SERVICE BULLETIN No. 209

Alternator Mounting Bracket Inspection

2900 Selma Highway
Montgomery, AL 36108 USA
Tel: 334-386-5400 Fax: 334-386-5450

Figure 1 - Alternator Mounting Bracket Inspection Area

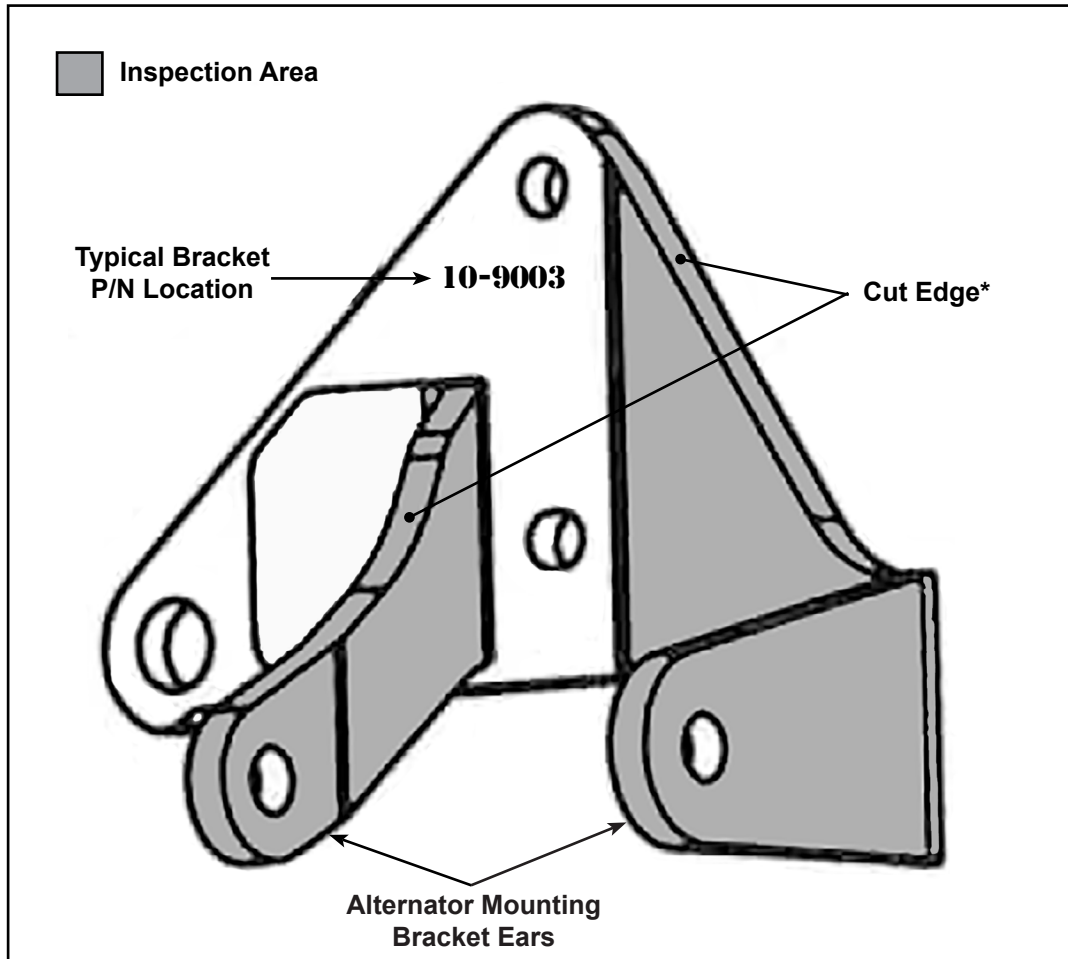
- (1) Installed alternators mounting kits listed in section 1.A could contain a cracked alternator mounting bracket P/N 10-9003 due to non-shimmed gaps between the alternator and alternator mounting bracket ears.
- (2) This SB is to advise the field of a potential condition and to supply inspection criteria to identify affected alternators using alternator mounting bracket P/N 10-9003.

- (1) If previous compliance cannot be verified through aircraft or engine maintenance records, use the same references to determine if an affected alternator has been installed. Refer to section 1.A, Effectivity.
- (2) If effectivity of the alternator cannot be established using aircraft or engine maintenance records, utilize the applicable aircraft engine maintenance manual to gain access to the alternator and inspect the alternator and alternator mounting bracket against criteria found in section 1.A of this SB.
 - (a) If the alternator **is** affected per section 1.A and alternator mounting bracket P/N 10-9003 is installed (Fig. 1), inspect the alternator mounting bracket ears for stress cracks. See Fig. 1, Inspection Area.

- 1) If the alternator mounting bracket **is** cracked, contact HET Product Support for assistance in obtaining a new alternator mounting bracket and shims and continue to 3.B, corrective action.

NOTE: Linear machining marks may be visible on the cut edge of the alternator mounting bracket/ears. They do not represent cracks.

Figure 2 - Alternator and Alternator Mounting Bracket Assembly

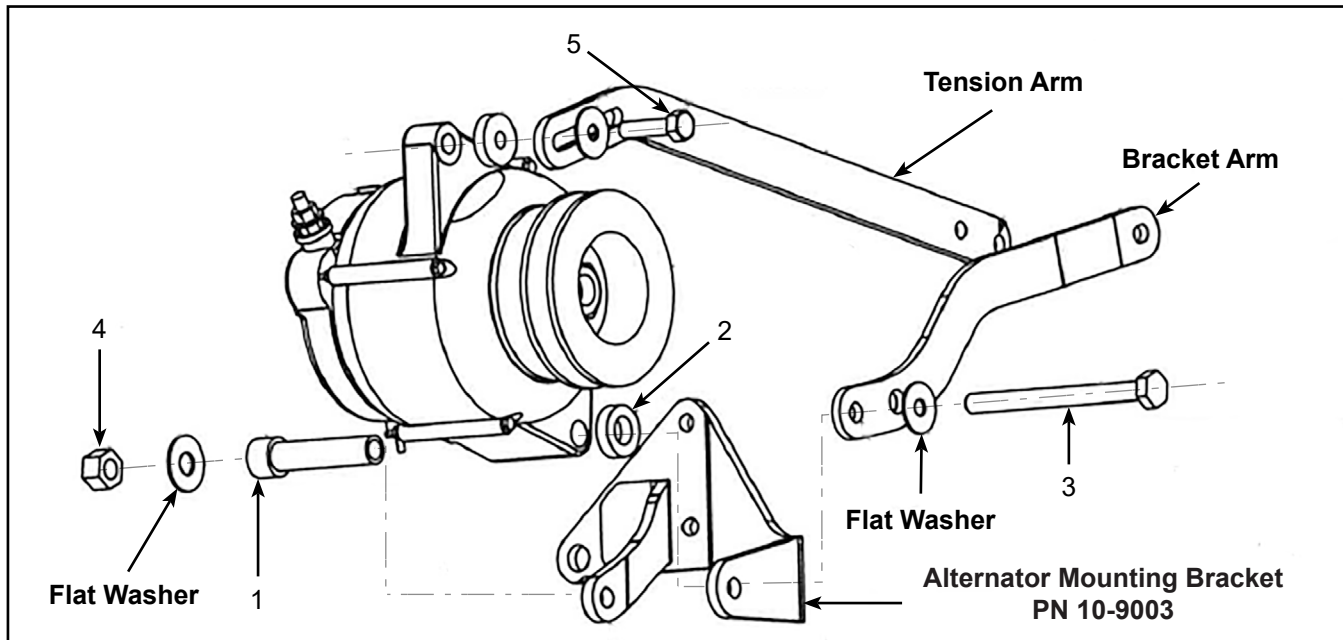
2) If the alternator mounting bracket is **not** cracked, see Fig. 2 for the following:

- a) Loosen the tension-arm bolt (5) holding belt tension.
- b) Loosen the bracket-ear/arm bolt (3).

- c) Align the alternator and spacers (1) & (2) to one side of the alternator mounting bracket.
- d) Use a feeler gauge and inspect the gap between the alternator mounting bracket ear and spacer.
- e) Record gap measurement.

1: The measured gap should be ≤ 0.007 .

2: If the measured gap is **not** ≤ 0.007 , continue to 3.B, Corrective Action.

3: If the measured gap **is** ≤ 0.007 , perform the following:

- a: Tension drive alternator drive belt in accordance with aircraft/engine maintenance manual and service instructions. Torque the bolt (5) to 140 in/lbs and install .032" safety wire.

- b: Install a new lock-nut and torque the bolt (3) and lock-nut (4) to 160-190 in/lbs.

See Fig. 2 for the following:

- (1) With the alternator, tension arm, and bracket arm in a free state, align alternator pulley and engine drive pulley.
- (2) Press spacers (1) & (2) against the alternator.
- (3) Install shims between the spacer (1) and/or (2) and the alternator mounting bracket until a combined gap between the alternator spacers (1 & 2) and alternator bracket of ≤ 0.007 is achieved.

- (4) Install a new lock-nut (4) onto bolt (3). Do not torque the lock-nut (4) at this time.

- (5) Using a feeler gage, verify total thickness of gaps is ≤ 0.007 .
- (6) Tension alternator drive belt in accordance with aircraft/engine maintenance manual and service instructions. Torque the bolt (5) to 140 in/lbs and install .032" safety wire.

- (7) Torque the bolt (3) and lock-nut (4) to 160-190 in/lbs.
